## MONITORING YEAR 3

### MOORES FORK STREAM MITIGATION PROJECT

Wildlands Engineering, Inc. (Wildlands) has reviewed the Division of Mitigation Services (DMS) comments from the Draft Monitoring Year 3 report for the Moores Fork Stream Mitigation Project. The following Wildlands responses to DMS's report comments are noted in italics lettering.

**Cross-Section Plots**

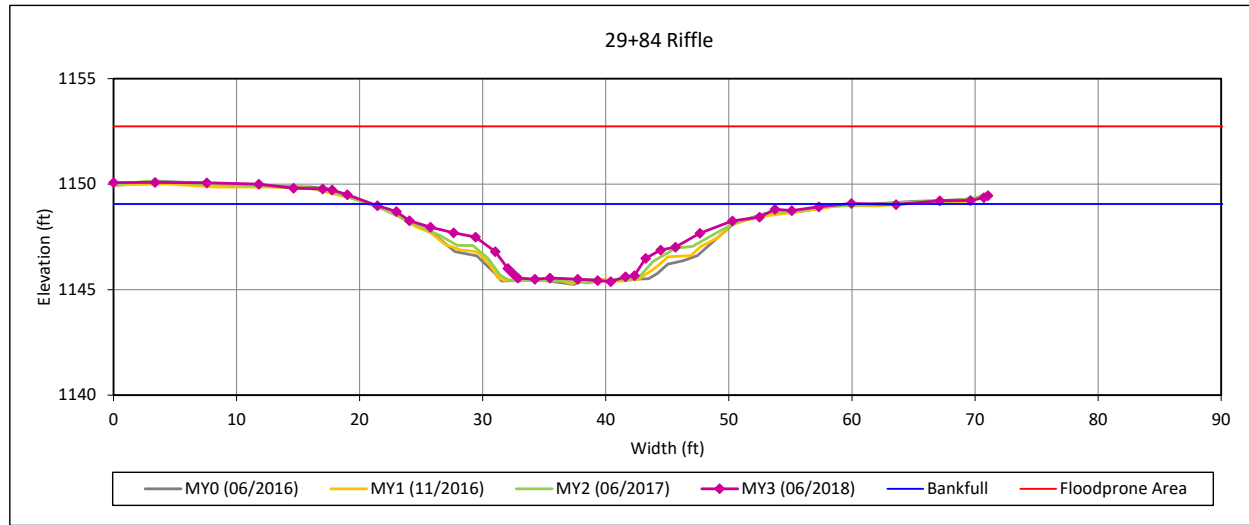
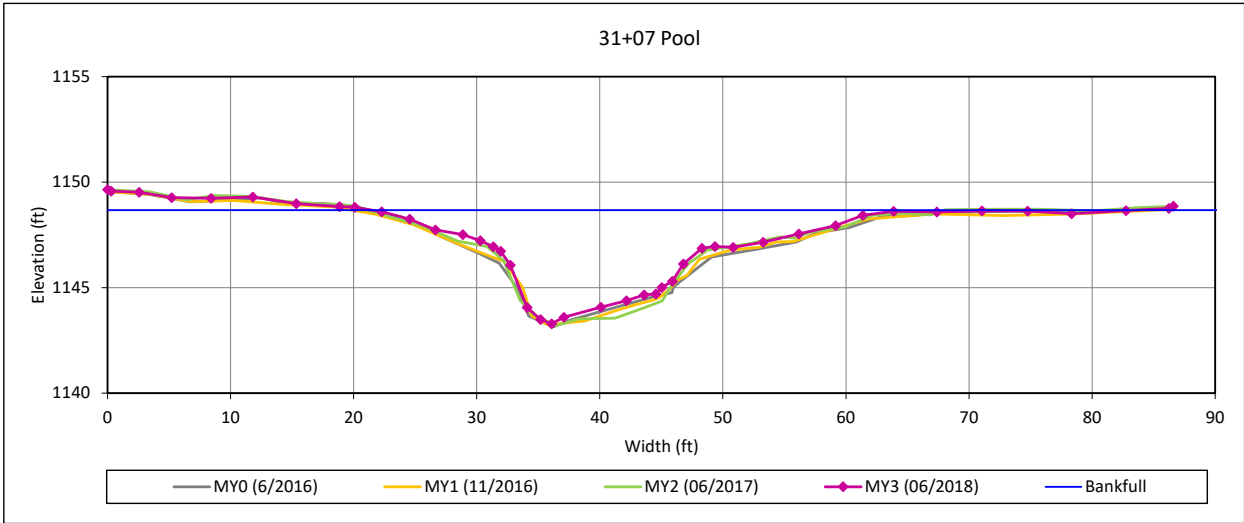
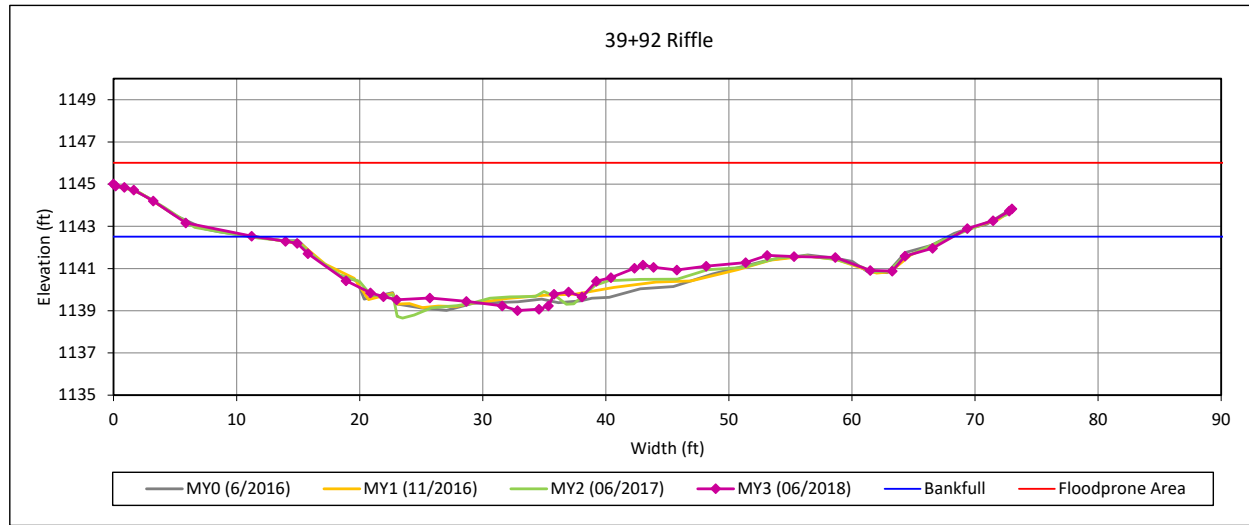
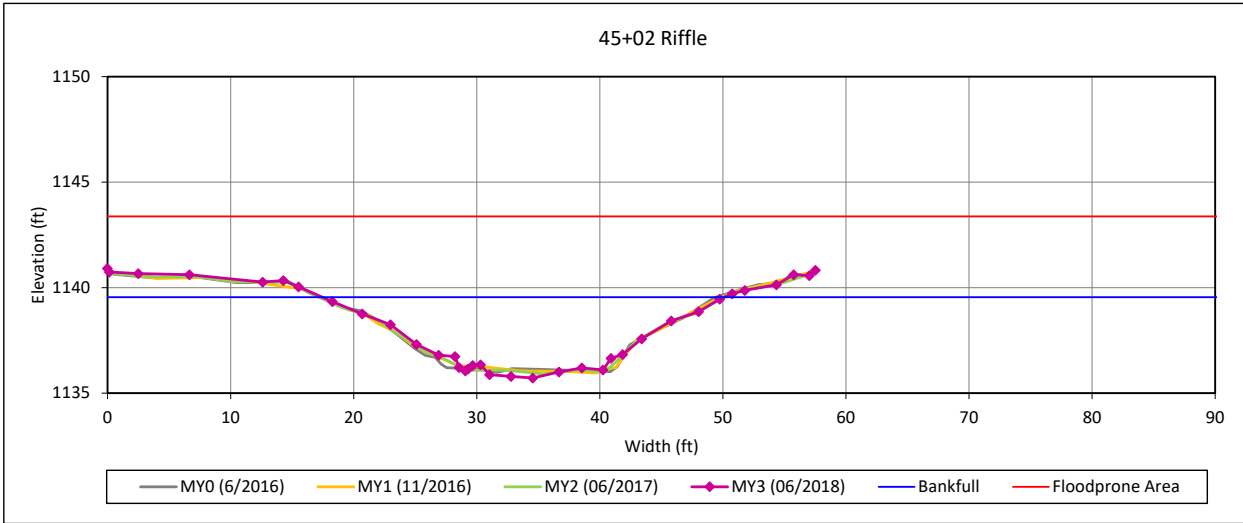
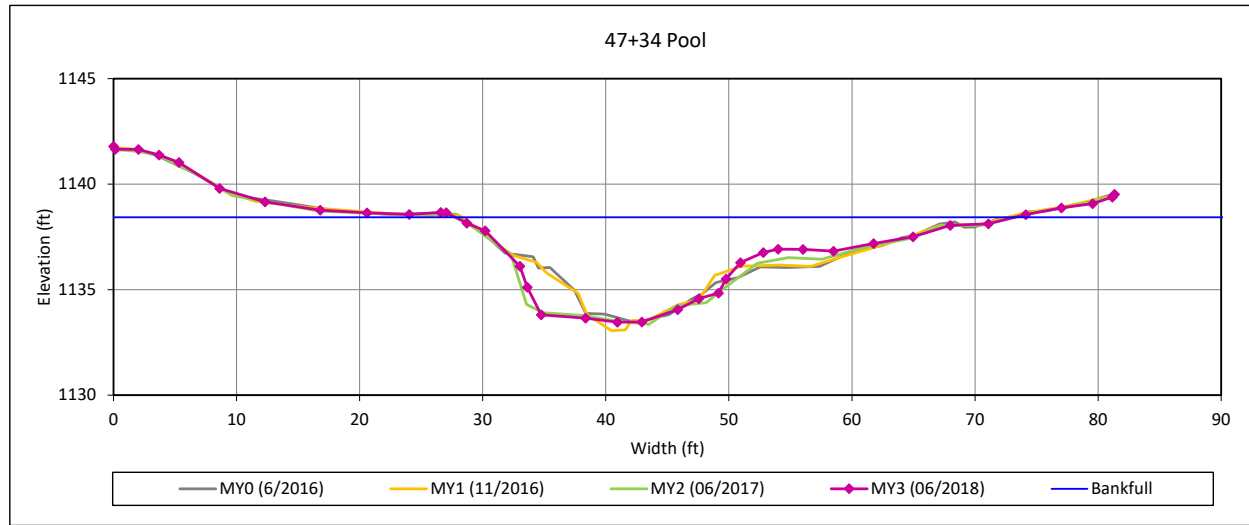
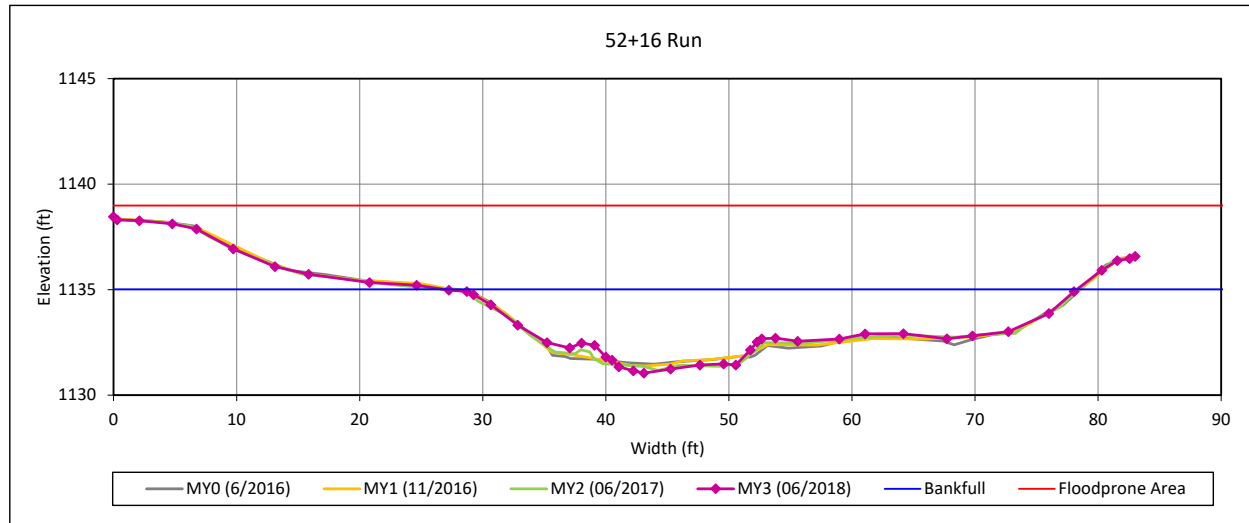
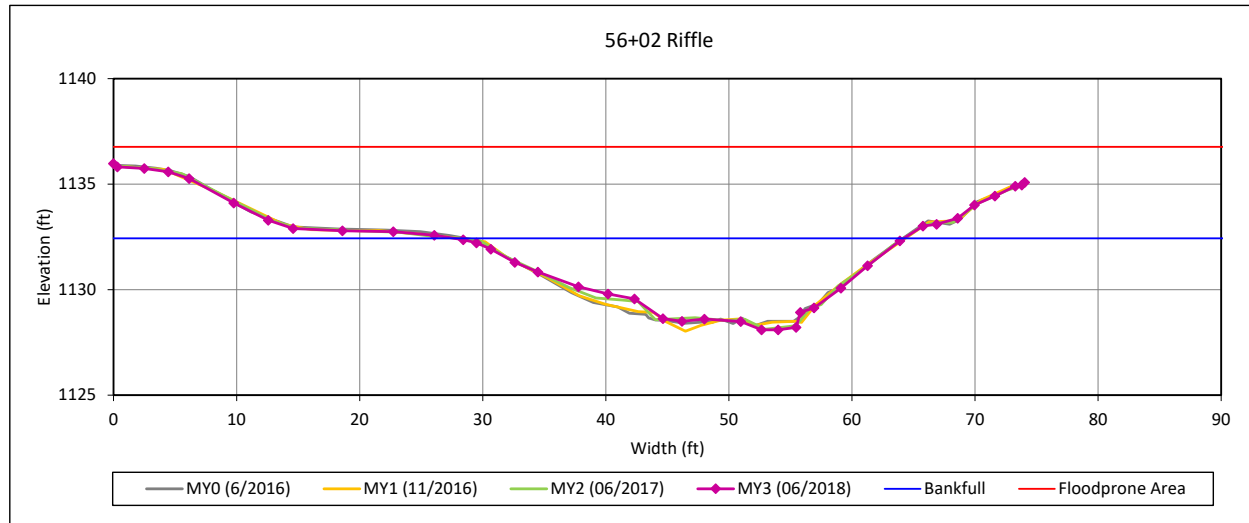
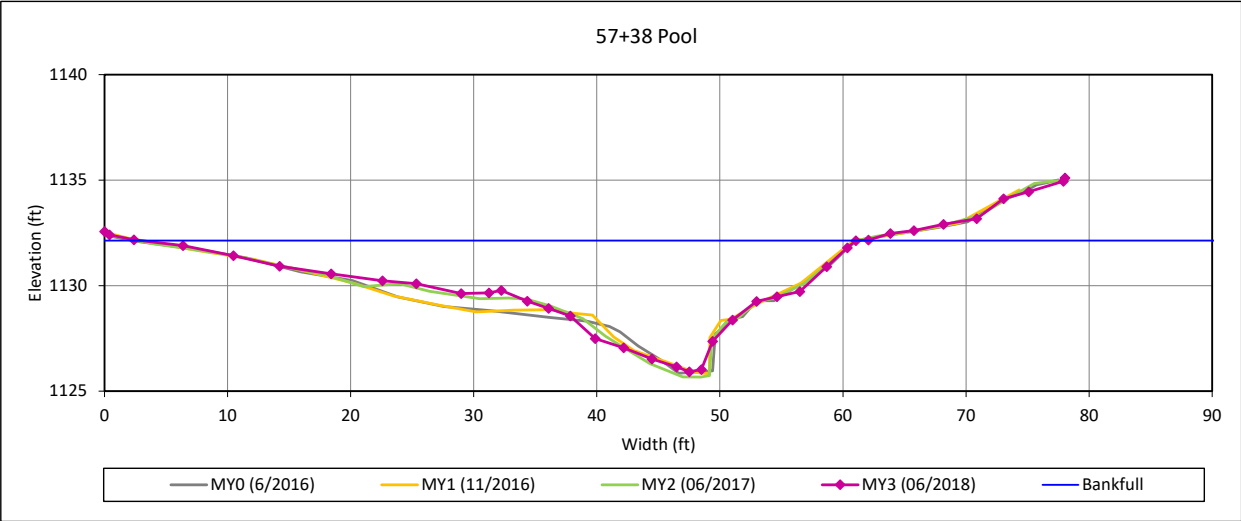
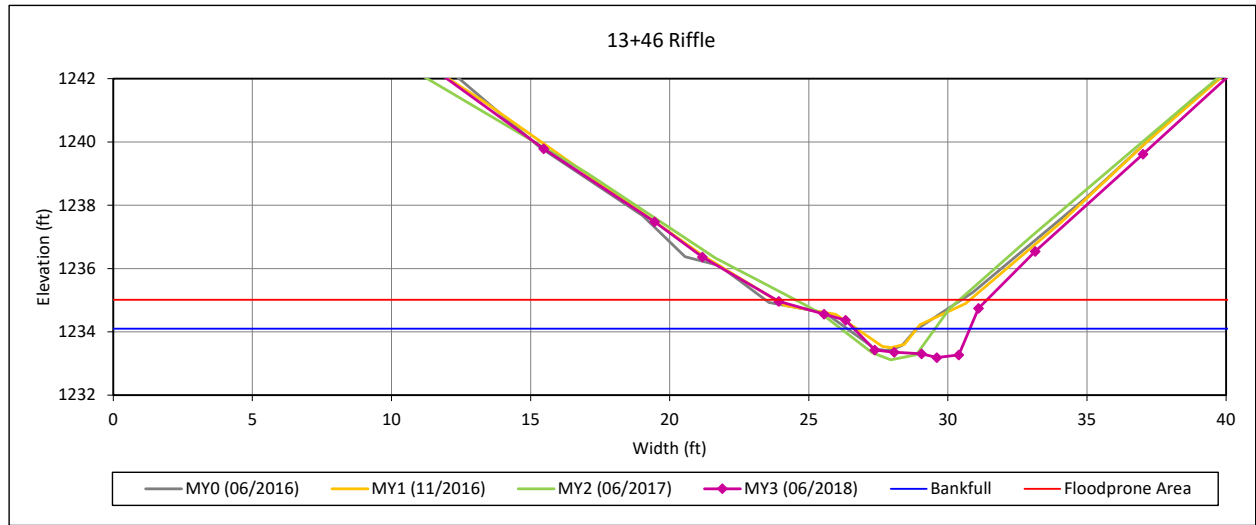
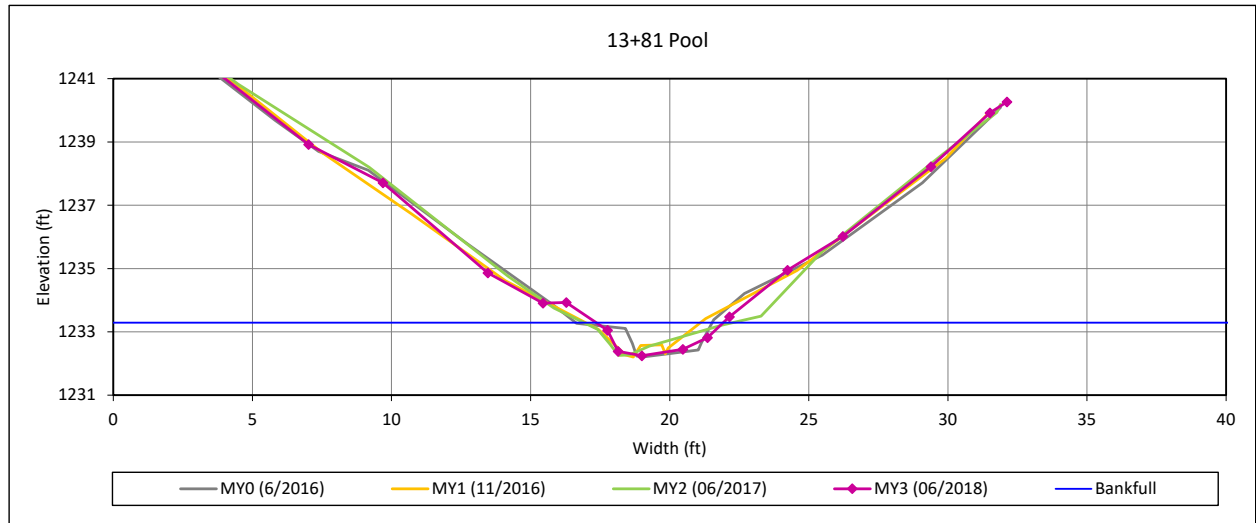
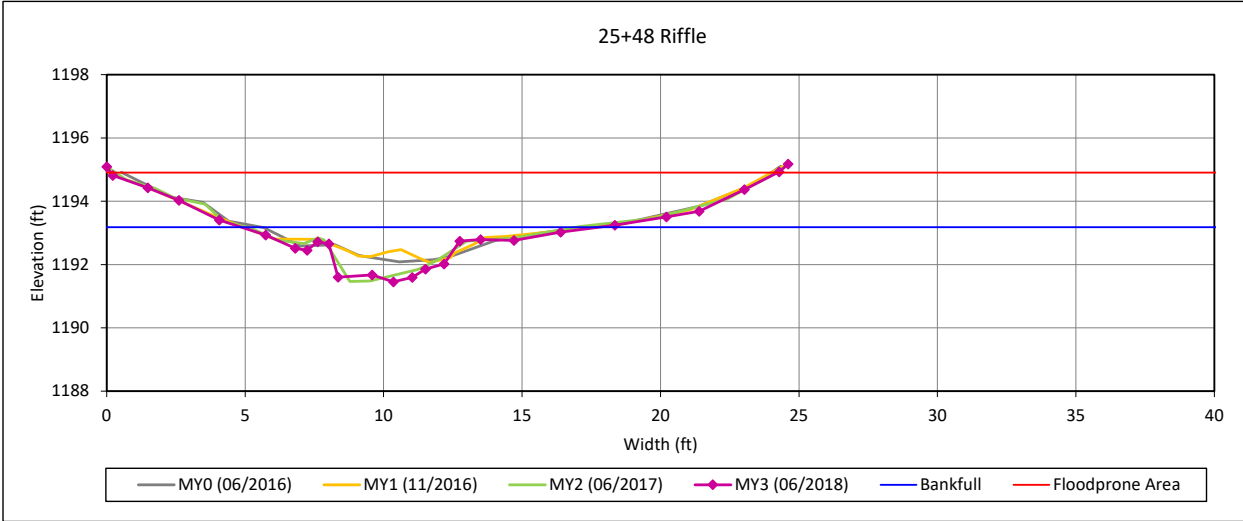
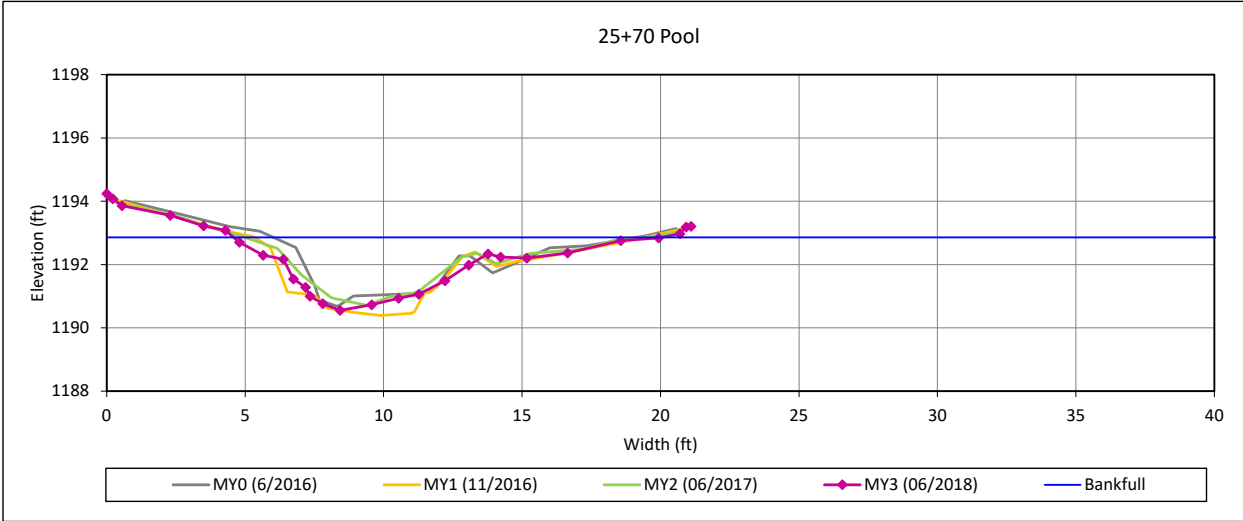
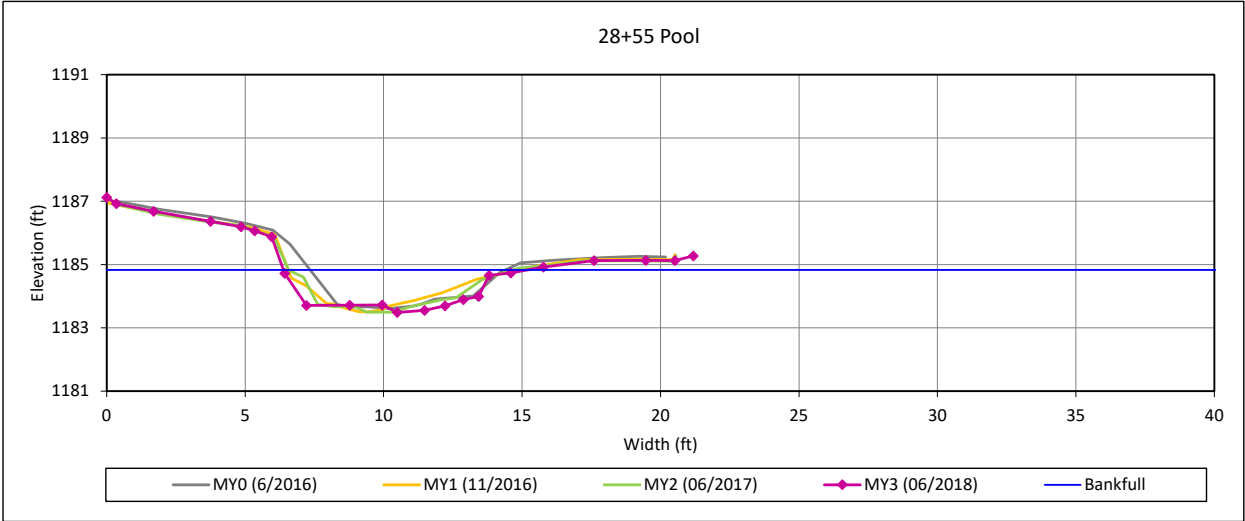
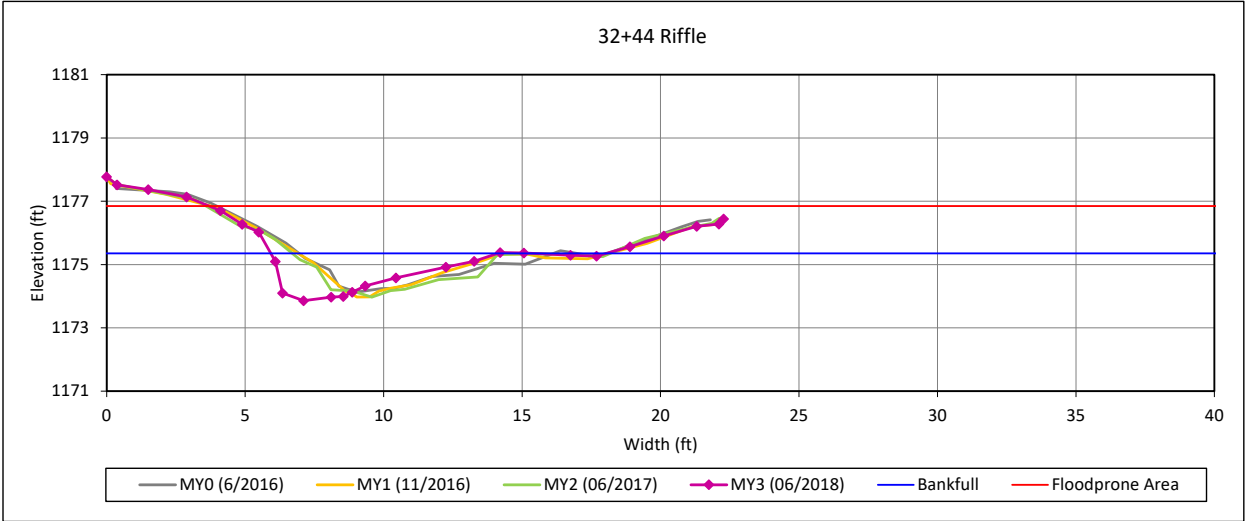
**DMS comment; Cross-sections: Please turn off markers for all years except MY3.**

*Wildlands response; All markers have been turned off except for MY3 on cross-section plots.*
